REPORT:**History**

On 15 March 2018, Council received a Development Application for a carport, to be located at 11 Town Beach Road, Tocumwal. In accordance with Council's *Development Control Plan*, Council notified all affected neighbouring properties about the proposed development and invited submissions.

The Development Application is for a proposed carport to be located at 11 Town Beach Road, Tocumwal. The carport will be used for general residential storage, vehicle parking, motorcycle storage and boat storage.

Figure 4 – elevation drawings of the proposed carport (street view from Sandy Lane)

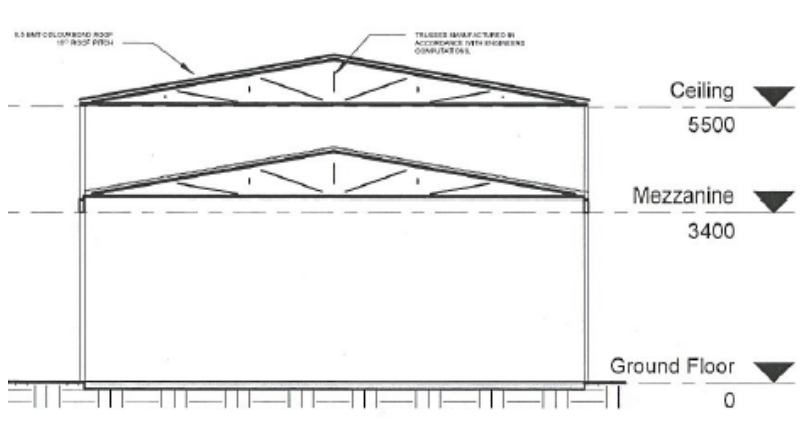
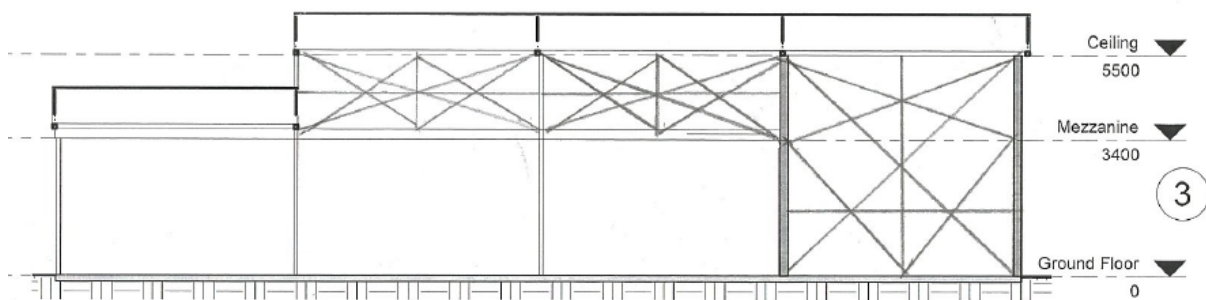
SUBMISSION	RESPONSE TO SUBMISSION
<p>Category of development? The submitter questions the category of the proposed development being a 'carport' when it has a second storey mezzanine and 25% of the structure being enclosed. For example that a carport is exempt development in the <i>SEPP (Exempt and Complying Development Codes) 2008</i>, when it is higher than 3 metres.</p>	<p>The <i>SEPP (Exempt and Complying Development Codes) 2008</i> is used as a guide to determine when a proposed development can be determined as a Complying Development, needs a Development Application with Council or that it can be developed as Exempt Development. A carport is a structure used to store vehicles and as there are open sides on both sides for a majority of the development it meets this description (the enclosed area is for the last 25% of the structure). When development doesn't meet this code then it is assessed using other legislation and Regulations and Councils Development Control Plan.</p>

<p>Southern section</p> <p>The submitter questions what the use of the southern section of the proposed carport as it is a double storey fully enclosed area. This southern section is directly adjacent to the</p>	<p>Argument noted - except for the point on the possible impacts of the development including noise and fumes, due to the proposed use for the carport for general storage associated with residential use, it has been</p>

<p>submitters existing dwelling, less than 3 metres from a full length west-facing window. The submitter questions what impacts this type of development have on them, including noise and fumes?</p>	<p>assess that there would be no impact in regards to noise and fumes. In addition it should be noted that there is significant vegetation consisting of large trees and shrubs located along the western boundary of complainants property which effectively screens the development site at present.</p>
<p>Further questions The submitter questions, are there going to be windows in the proposed carport enclosed area as there are window frames sitting in the existing carport? Will this building be a site of a backyard business generating noise, traffic and parking congestion?</p>	<p>There are no proposed windows in the enclosed area of the proposed carport. The proposed use of the carport is for garden machinery, two vehicles, collectable motorcycles and boats. Furthermore, any approval conditions would include that the proposed carport be used for storage associated with residential purposes.</p>

Figure 6 – site plan for the proposed carport

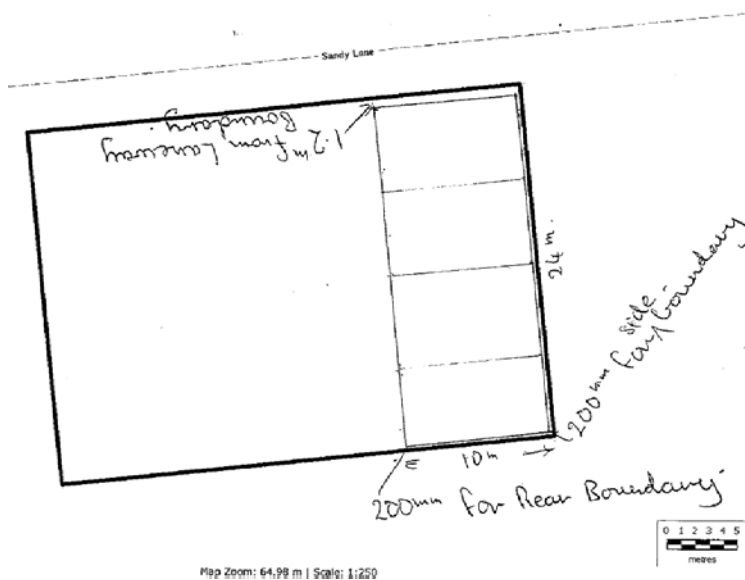
<p>Reduced setback to boundary, height and size The submitter objects to the reduced setbacks stating that the proposed building is too close to the boundary, is too high and is overlarge. The impacts of the boundary proximity, height and scale of the building is reflected in all other points in the submitters submission. The development does not meet the control guidelines of the Berrigan Development Control Plan chapter 2.2 Streetscape where the bulk and scale should be kept of a compatible size with the existing or likely development in the residential precinct. The building will cover 25% of the Lot and extends almost the entire eastern boundary. For a "village" zoned neighbourhood it has the visual bulk and height of an outbuilding one might expect on a rural property or on the outskirts of town. The building is set in the 'front' of their dwelling (in regards to the submitters residential dwelling being orientated to Sandy Lane).</p>	<p>Discussion points noted – except for the second paragraph in regards to fire separation regulations, the proposed development in this regard has been assessed and the proposed development addresses the guidelines for fire separation.</p>

<p>Fire Separation - In order to meet the fire separation standards of the Building Code of Australia the boundaries would have to be setback to 900 mm to comply. The reduced setback would cause overshadowing as discussed below. Would footings fit into the proposed 200mm setback? Would a 200 mm setback enable the construction of a boundary fence along the eastern boundary? Is there going to be heating and cooling in the workshop and mezzanine and would the reduced setback affect this?</p>	
<p>Energy Efficiency The submitter purchased their dwelling due to the north facing windows. They believe the following will be affected by the proposed carport:</p> <ol style="list-style-type: none"> a. Solar Access - the submitter believes that the proposed development will cause overshadowing on their dwelling during Winter Solstice from 12:00pm onwards. Their dwelling has been positioned for optimal position for controlled solar access with a northern exposure to allow winter sun into their living area during the day. At the start of winter they traditionally cut back some vegetation on the northwest corner of their Lot to gain more afternoon sun and on the northeast corner for morning sun. Figure xx shows the living areas on the northern aspect of the dwelling and winter sun projecting onto the north facing windows at 2:00pm on 4 June 2018. Figure xx is a shadow diagram drafted by the submitter indicating potential impacts from the proposed carport. The submitter believes that the shading cast by the upper storey by 2:30pm will 	<p>The issues of solar access to the neighbouring property have been assessed against relevant planning policy and legislation and given that there is solar amenity enjoyed by the neighbouring property during the hours of 9am to 3pm, the proposed development will have only a minor effect on solar amenity to the northern outdoor and living areas on the neighbouring dwelling from 2:30pm onwards.</p> <p>As evidenced during the site visit undertaken by Councillors and Council staff the dwelling was receiving effective solar access at 2.30pm and the erection of the proposed carport would not reduce this amenity.</p>
